Re: Florida Power & Light Company
Proposed Turkey Point Units 6 and 7
Docket Nos. 52-040 and 52-041
Response to NRC Request for Additional Information Letter 120329
(eRAI 6354 Rev. 0) Related to ESRP Section 2.3.1 - Hydrology

NRC RAI Letter No. 120329 Dated April 3, 2012

SRP Section: EIS 2.3.1 – Hydrology

Figure 1. Extent of "Continuous Seagrass" and "Patchy (Discontinuous) Seagrass"

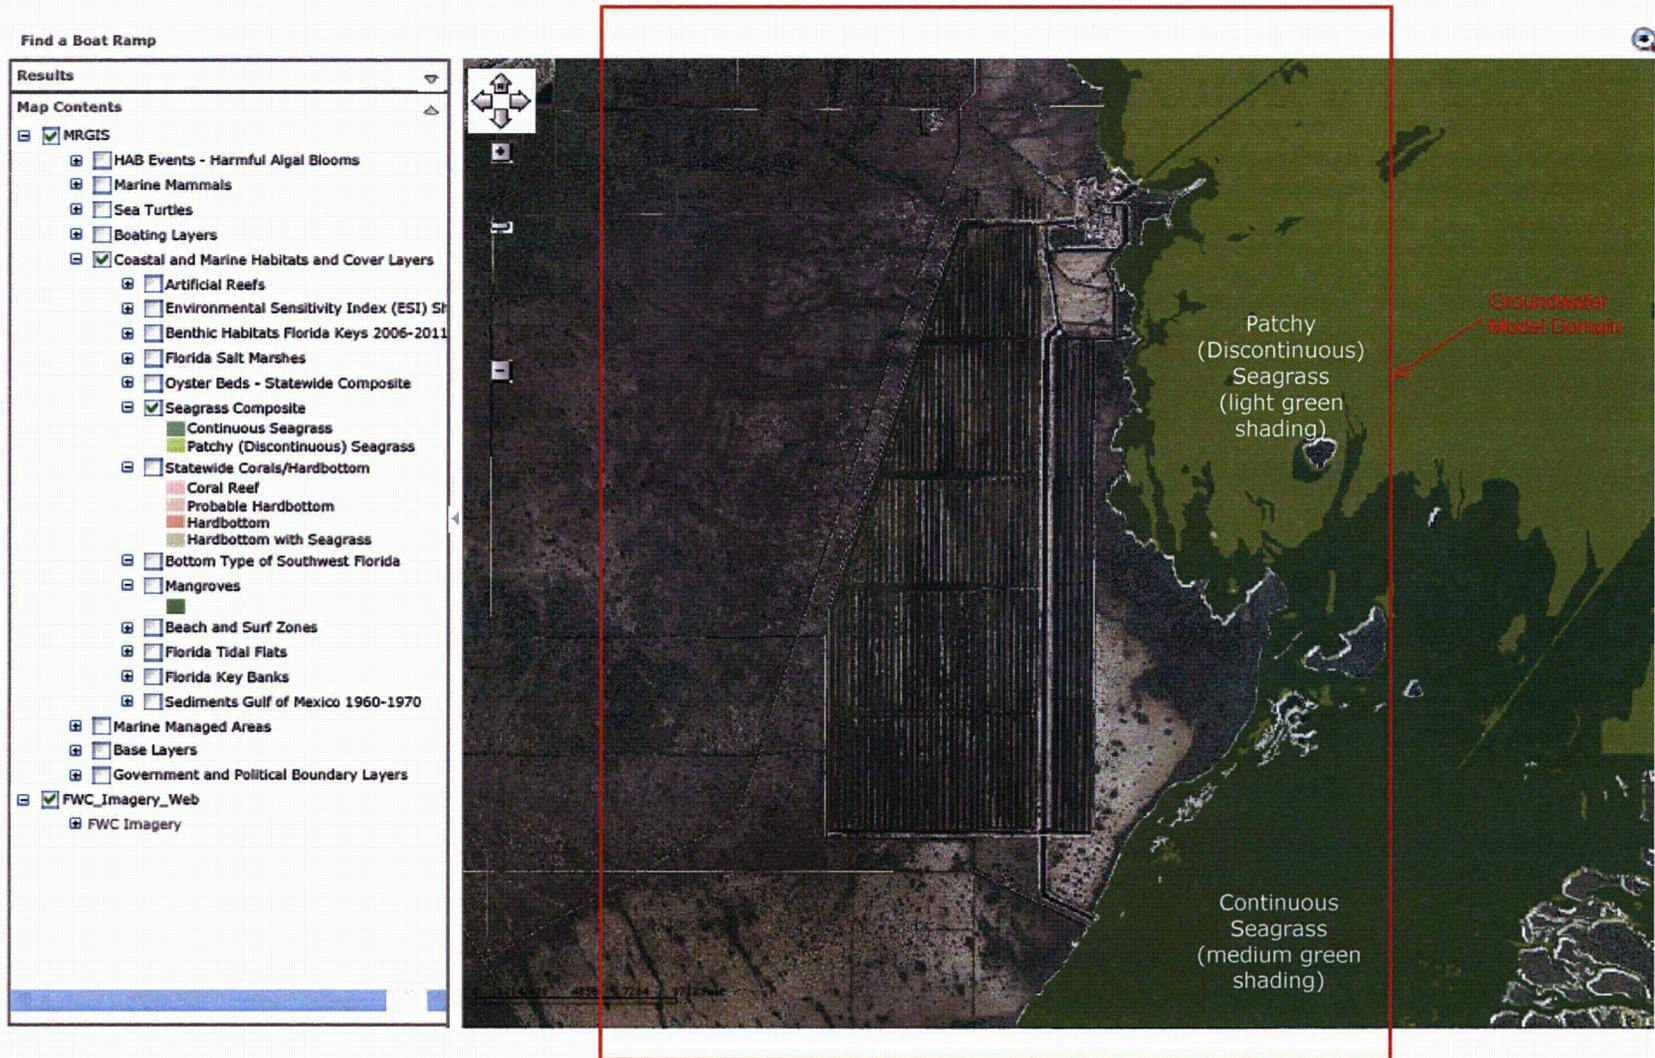
Provide any available information on how measurements of the hydraulic conductivity of the sediment found at the bottom of Biscayne Bay were determined.

The extent of the above benthic zones within the model domain is shown on two figures provided with this response:

- Figure 1 – Extent of "Continuous Seagrass" and "Patchy (Discontinuous) Seagrass" (FWRI 2012)
- Figure 2 – Extent of "Hardbottom with Seagrass" and "Mangroves" (FWRI 2012)

A seagrass survey was conducted in 2009 along 26 transects surrounding the Turkey Point peninsula (EAI 2009). The transects extended to approximately 300 m from the shoreline. The seagrass in this area includes turtle grass (*Thalassia testudinum*) and, to a lesser extent, shoal grass (*Halodule wrightii*). *Thalassia* seagrass coverage ranged from 0% (not present) to >90%, with highest coverage immediately surrounding the peninsula (Figure 2 in EAI 2009). The area with greater than 50% seagrass coverage is consistent with the extent of the MRGIS zone around Turkey Point of “Continuous Seagrass” shown in Figure 1 of this response.
